11 June 2021

**RE: LOT 2255 Adina Street Illoura Precinct  
JORDAN SPRINGS DESIGN PANEL APPROVAL**

**Richard Chester**  
Estate Design Approvals Officer  
BEVERIDGE WILLIAMS

Concept Landscape

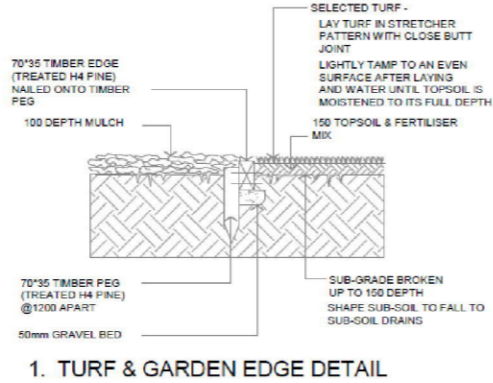
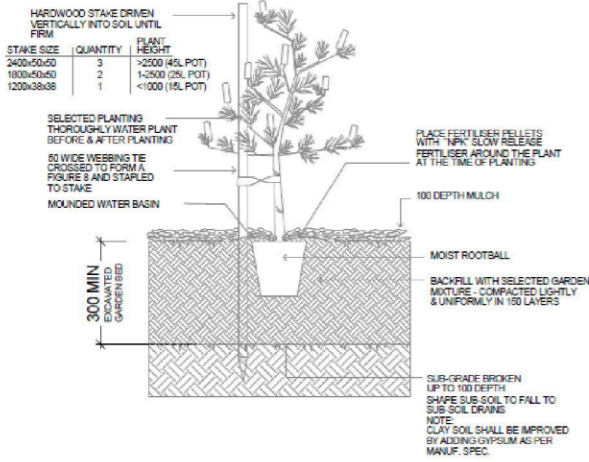
- Refer to landscape plan for driveway requirements. Existing footpath to remain and not be cut to suit driveway.
- The side and rear fencing is to be 1.8m high 'Lysaght Smartascreen' or equivalent in Colourbond 'Woodland Grey' colour. Colourbond boundary fencing to not continue forward of the built to boundary walls, gate positioned minimum 7.5m behind the front boundary or 2m behind the adjacent façade, whichever is greater. Refer to Landscape plan.

Boundary Fence -1800mm high  
Lysaght Smartacreen in  
Woodland Grey or equivalent

LENDLEASE INSTALLED FOOTPATHS MUST  
REMAIN IN PLACE AND LEFT IN PLAIN  
CONCRETE.
